SUBJECT: Forwards summary on HPI sys analyses associated w/question 4
in NRC 970505 staff request for addl info.

Subject: Oconee Nuclear Station
Docket Nos. 50-269, -270, -287
Response to Request for Additional Information
on the High Pressure Injection (HPI) System
NRC TAC No. M98454

Attachment 1
Supplemental Information Regarding Question 4
in May 5, 1997 NRC Request for Additional Information

FIGURE 4.1 - CRITICAL FLAW SIZE DISTRIBUTION FOR HPI/MU NOZZLES

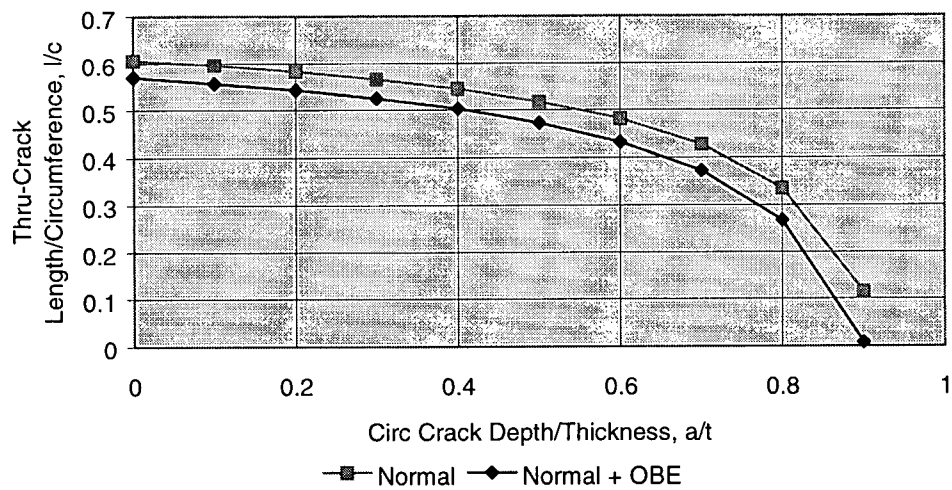
Provide a fracture analysis to determine the critical flaw size required to fracture the piping under normal loads during HPI injection or makeup conditions.

Based on the bounding stresses at the safe-end to piping welds for the 1A1 and 1A2 nozzles during normal operation, which include those which occur during HPI and makeup injection, the resulting size of critical flaws is shown in Figure 4-1. This figure shows the combination of through wall partial circumference flaws combined with a 100 percent circumferential flaw that would reach the limit load as defined in Section XI, Appendix C during normal operation with a safety factor of 1.0.

FIGURE 4.2 - ALLOWABLE FLAW SIZE DISTRIBUTION FOR HPI/MU NOZZLES

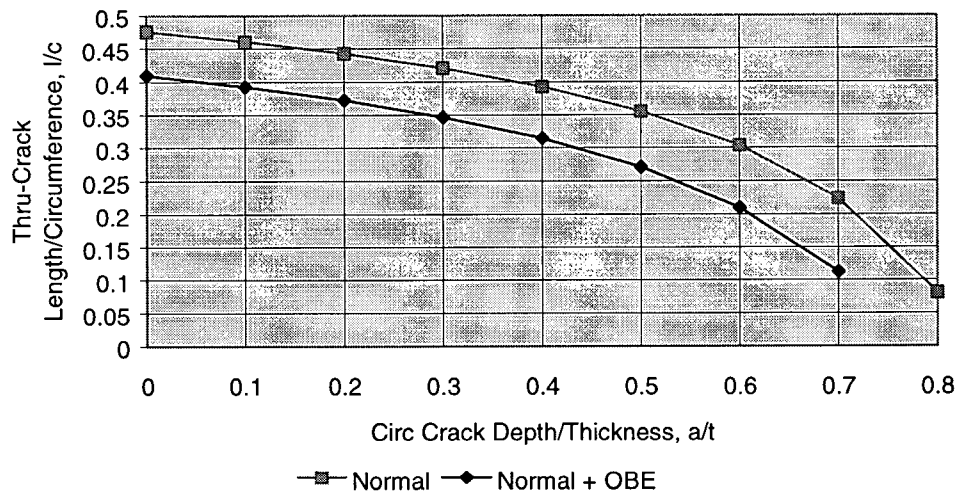
In determining the margins-to-failure, identify all assumptions and inputs into the analysis, including stresses and material characteristics.

Figure 4-2 shows the allowable flaw size that meets the stress criteria of ASME Section XI, Appendix C, including the factor of safety of 2.77. This figure shows that for a 30 percent part-wall circumferential through-wall crack, combined with a 42 percent of circumference through wall crack would meet Code stress criteria (without the OBE). With the OBE, the allowable through wall crack could be 35 percent of the circumference. The observed cracking in Unit 2 can be approximated as a 33 percent of circumference through-wall crack with a circumferential crack in the remainder of the pipe that is less than 30 percent of thickness. Thus, Section XI stress criteria is satisfied.
